Give it Space! *a locally preferred alternative for beach restoration at Surfers Point*

Proposed Surfers Point Managed Retreat Project

Alternative 1: buried seawall with no action in retreat zone

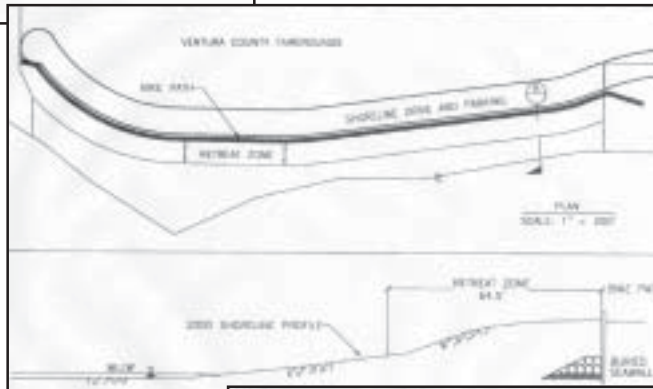
- * what will the retreat zone look like? a dirt lot?
- * why build a buried seawall once the damaged facilities are moved out of danger?

Alternative 2: cobble berm with dune and buried seawall

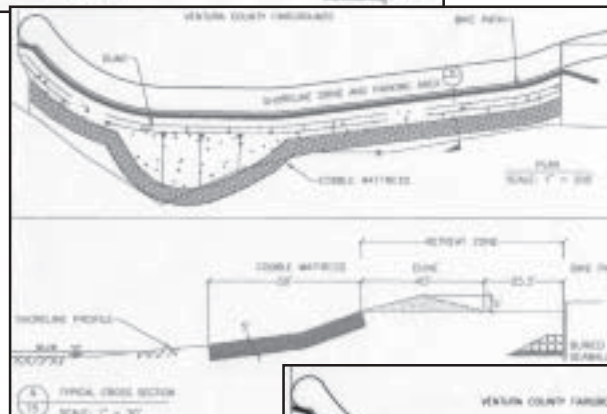
- * why dump tons of cobble on the beach near the rivermouth?
- * what about the artificial fill beneath the retreat zone? we don't want more debris from decades of dumping to erode onto our beach!
- * why build a seawall if the beach is to be renourished in the future with sand and cobble?
